Access Compliance Report Public Rights-of-Way (Curb Ramps)

Main Street: HOLT_AVE Cross Street: VANDERLIP_AVE Location: SW

ADA ID: RPRK211011131028 Ramp Type: Type 4 - Parallel Initial Pass/Fail: Fail Overall Compliance: No Severity Score: 16

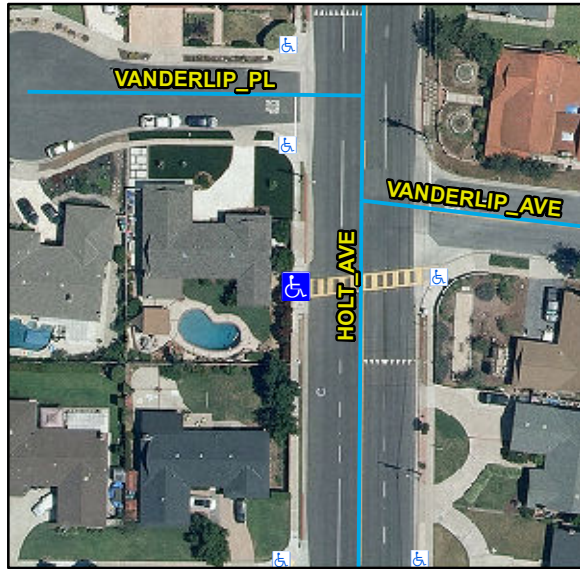
R304.3.2, R304.5.3, STD 1115

Compliance	Description	Data	Compliance	Description	Data
N/A	Ramp Length LT (in)	118	N/A	Ramp Length RT (in)	117
Yes	Ramp Width LT (in)	82	Yes	Ramp Width RT (in)	82
No	Ramp Run Slope LT (%)	9.3	Yes	Ramp Run Slope RT (%)	3.9
No	Ramp Cross Slope LT (%)	3.5	Yes	Ramp Cross Slope RT (%)	1.5
N/A	Landing Present	N/A	N/A	DWS Provided	N/A
N/A	Landing Length (in)	N/A	N/A	DWS Contrast	N/A
N/A	Landing Width (in)	N/A	N/A	DWS Length (in)	N/A
N/A	Landing Run Slope (%)	N/A	N/A	DWS Full Width	N/A
N/A	Landing Cross Slope (%)	N/A		DWS Offset Type	N/A
N/A	Landing Movement Obstructed?	N/A	N/A	DWS Offset Left (in)	N/A
	Landing Movement Type	N/A	N/A	DWS Offset Right (in)	N/A
N/A	Landing Shared	N/A			
N/A	Clear Space	N/A			
N/A	Clear Space To Crosswalk (in)	N/A			
N/A	Marked Crosswalk 1	Yes	N/A	Marked Crosswalk 2	N/A
	Crossing 1 Direction	E		Crossing 2 Direction	N/A
	Marked Crosswalk 1 Width (in)	120		Marked Crosswalk 2 Width (in)	N/A

Remove & Replace Entire Ramp.
